Re: **Initial Submission Review – Porteos** (Infrastructure CSP)
Application Number: **DA-1903-13**
Case Number(s): **2019-6032-00**

INFRASTRUCTURE CONTEXTUAL SITE PLAN NO.5 AT PORTEOS

INFRASTRUCTURE SITE PLAN
E. 64TH AVENUE PLAN VIEW

SHEET NUMBER
10

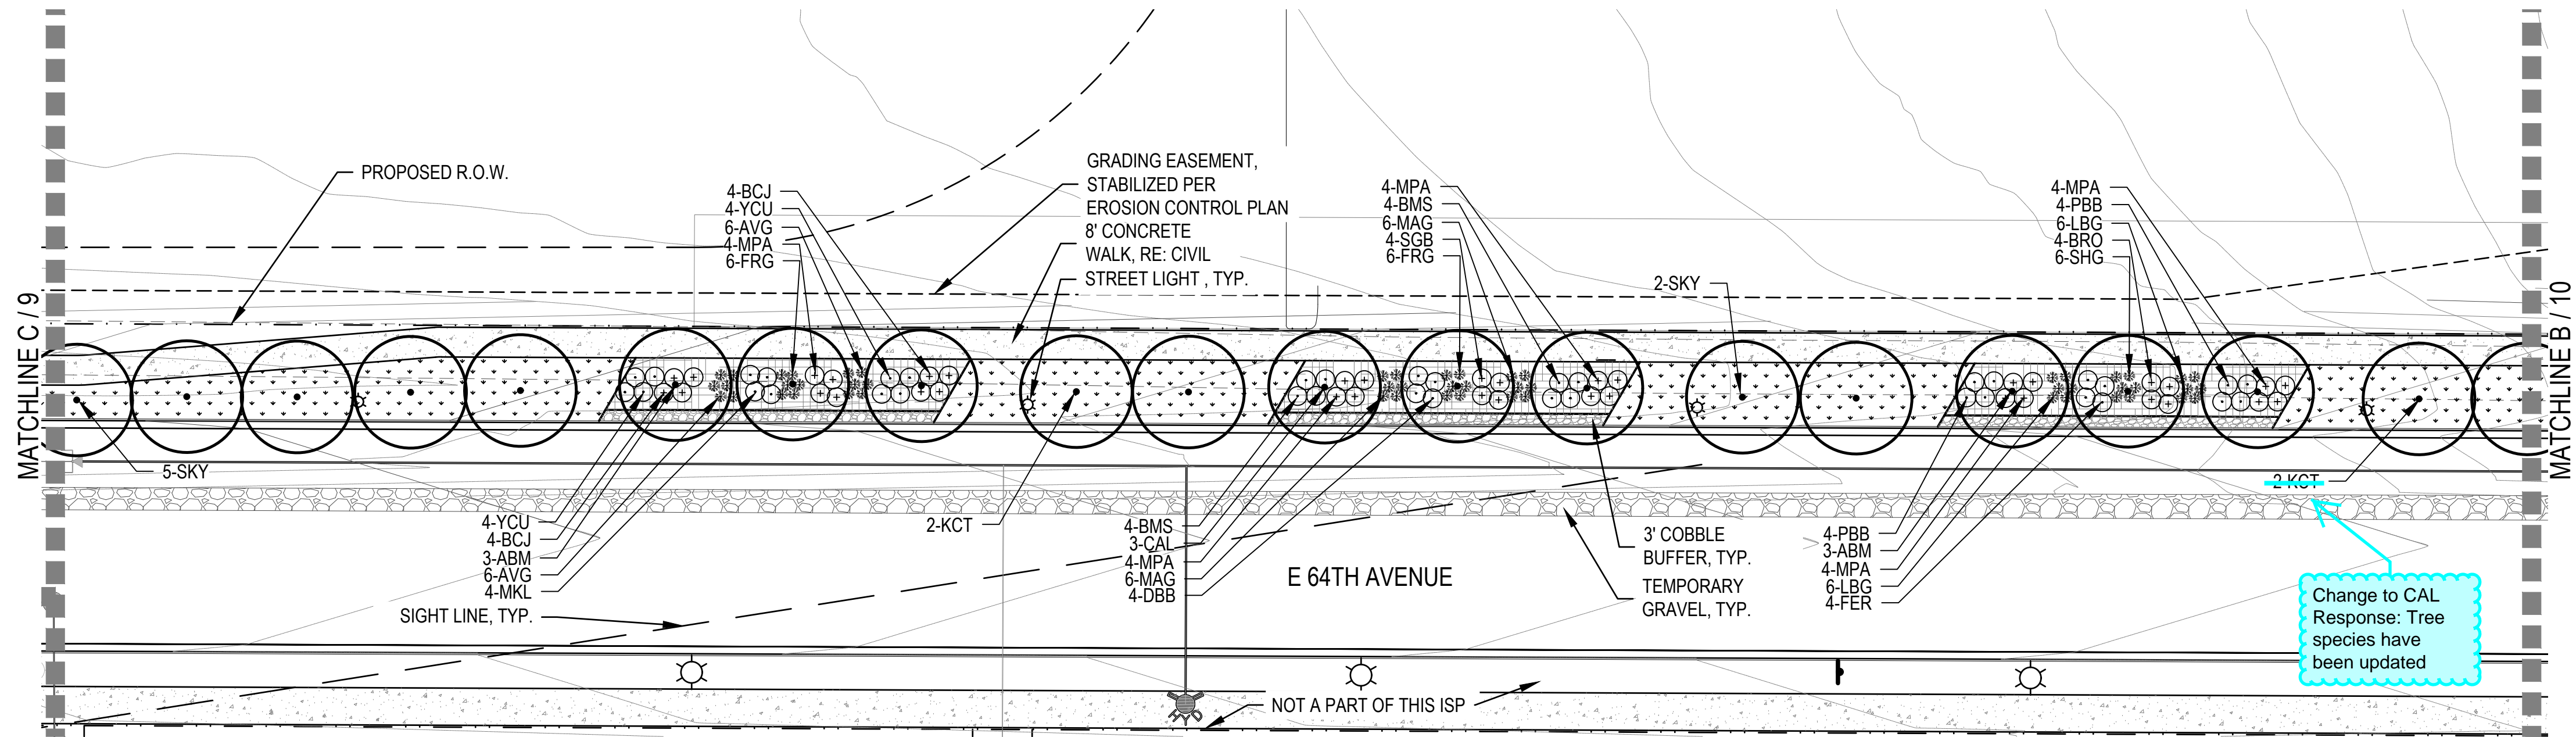
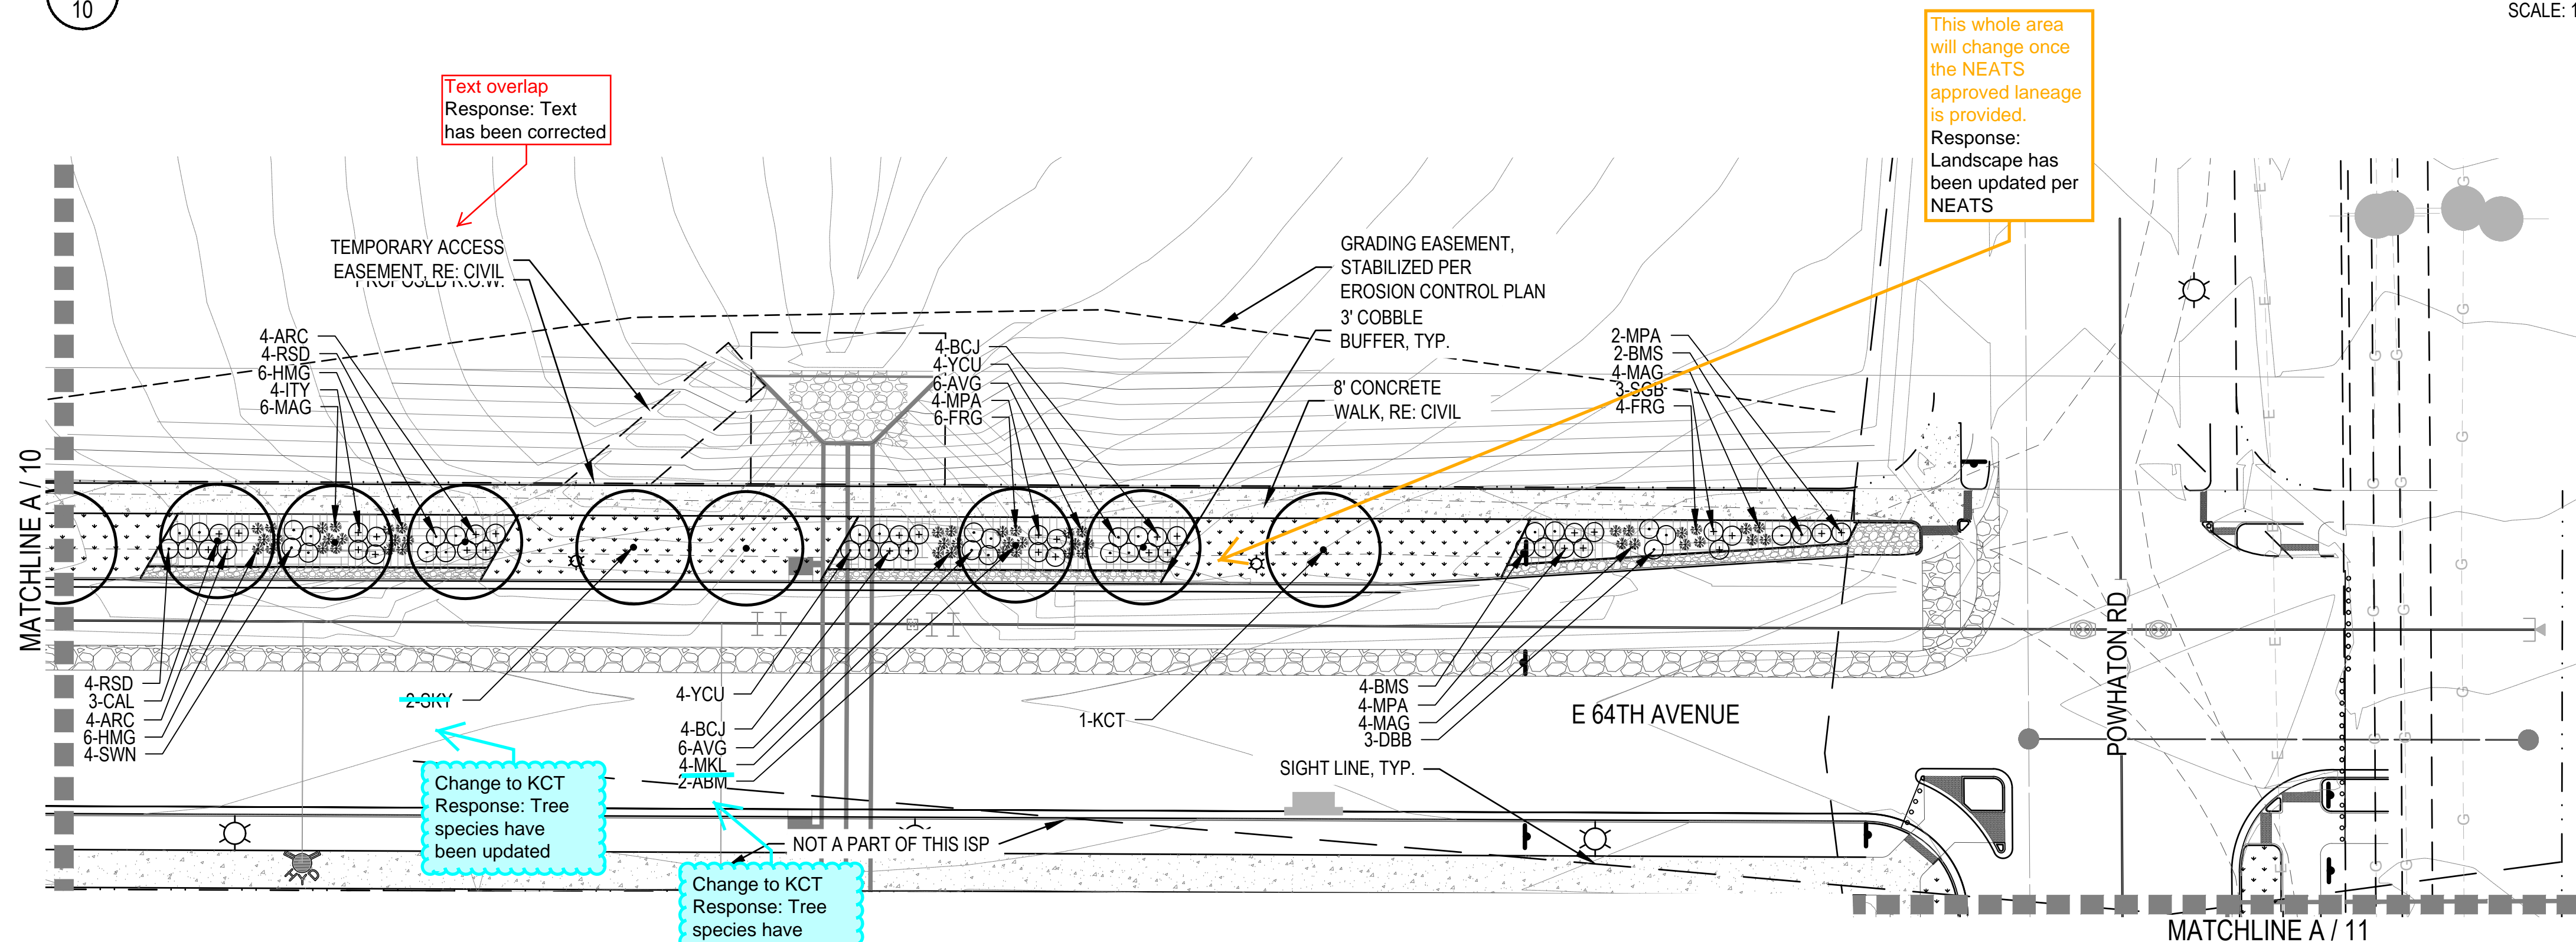
- Change some of tree species per the comments.

Response: Tree species have been changed.

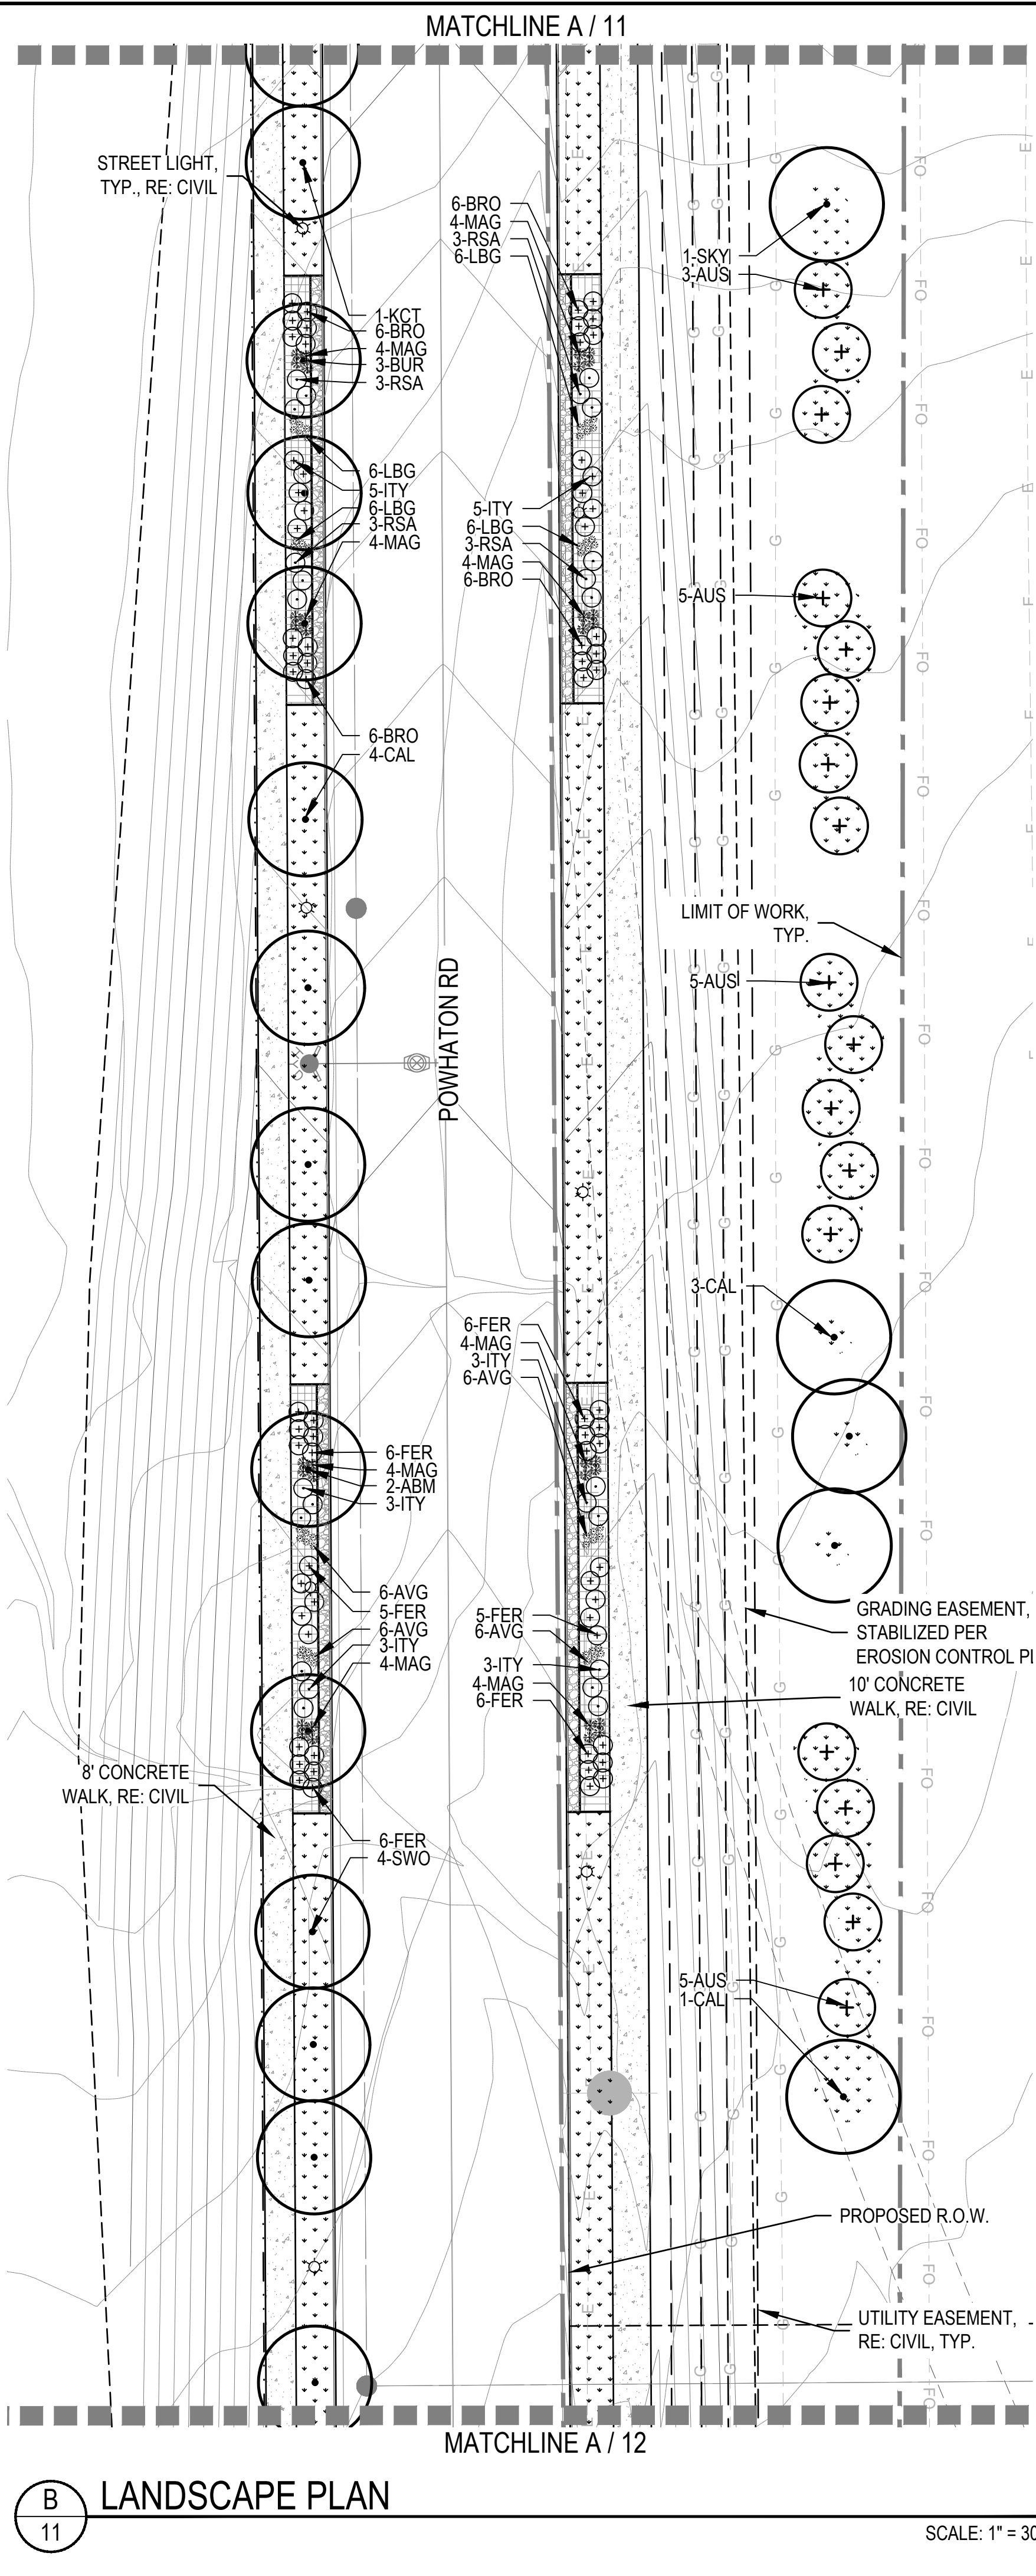
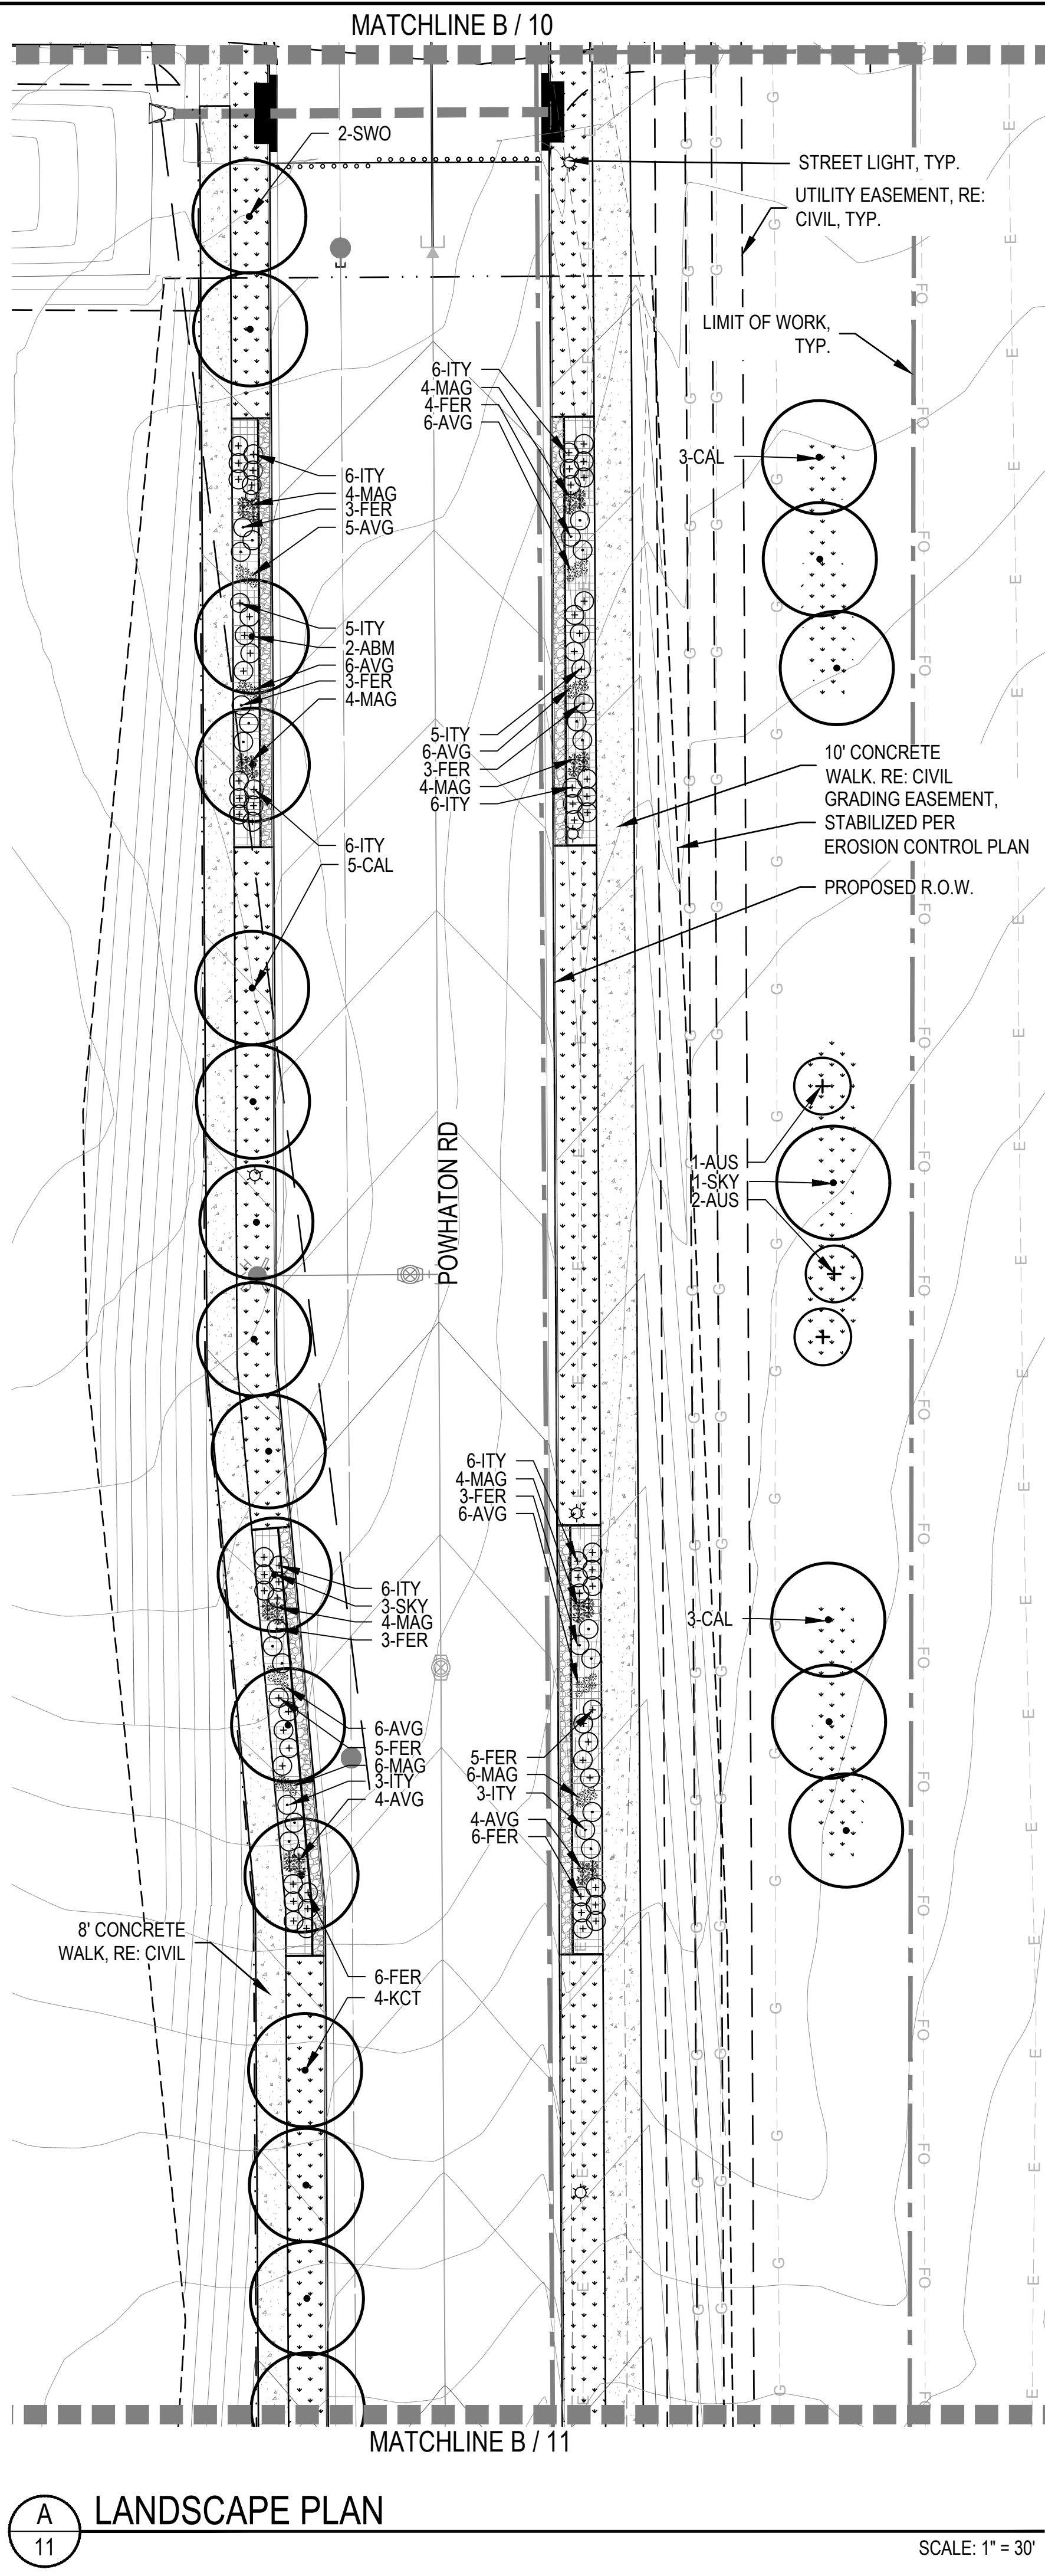
Location of all of these landscaping will change once the
NEATS required laneage is included.
Response: Landscape has been updated per neats laneage.
